National Capital Region Transportation Plan CIA Master Plan and Environmental Assessment

CIA Master Development Plan
Environmental Assessment
National Capital Planning Commission

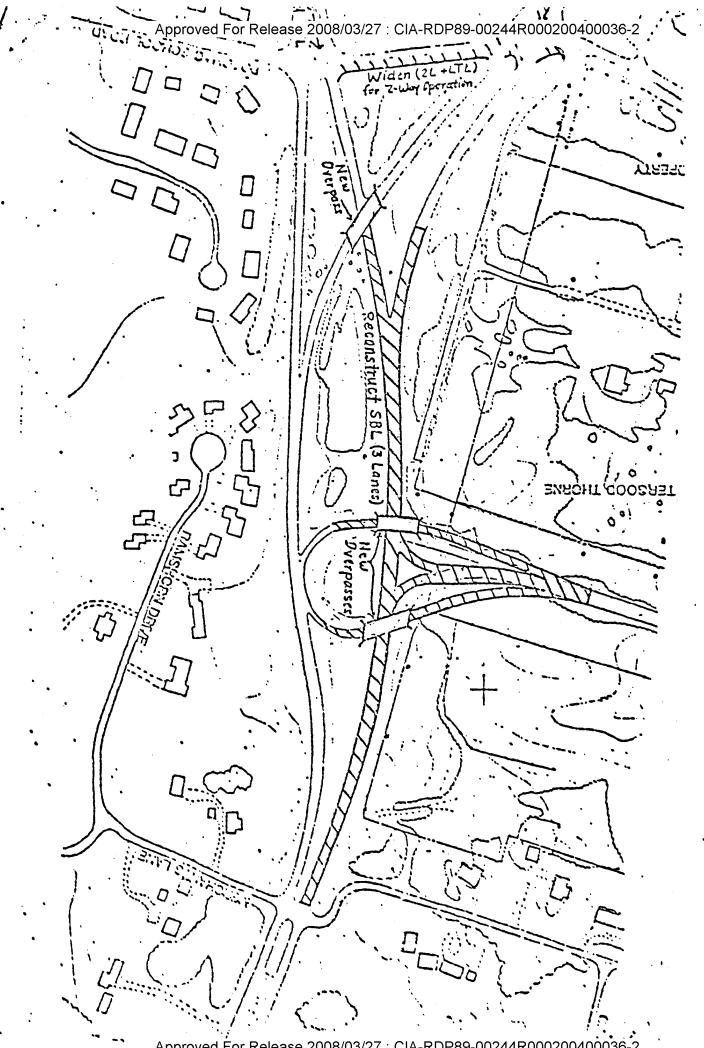
Approved For Release 2008/03/27 : CIA-RDP89-00244R000200400036-2 In order to ov :ome traffic problems created / the CIA expansion. the following roadway improvements are needed:

Reconstruct southbound Route 123 generally between northbound Route 193 and Merchants Lane and provide overpasses at northbound Route 193 and at the main CIA entrance and exit, and reconstruct the entrance from southbound Route 193, all of which should permit a smooth flow of traffic to and from the CIA complex.

Widen the existing eastbound ramp from northbound Route 193 to southbound Route 123 to provide two-way operation and separate left turns at intersections. In conjunction with this, a northbound left turn lane should be added on Route 123 at the Potomac School Road intersection. This should divert significant traffic from the main CIA entrance, as well as accommodate vehicles presently making U-turns at this location. _

Provide a left turn lane on northbound Route 193 at the FHWA entrance to further divert traffic from the main CIA entrance.

A schematic drawing is provided to better describe the above recommendations. A sketch plan cost for this improvement is approximately \$2 million. The Dapartment looks to the federal government for a package proposal for the implementation of this Master Plan, which includes the transportation improvements concurrent with the addition of this one million square feet of office space. Without the transportation improvements, the Department must suggest that any additional development at this location be denied.
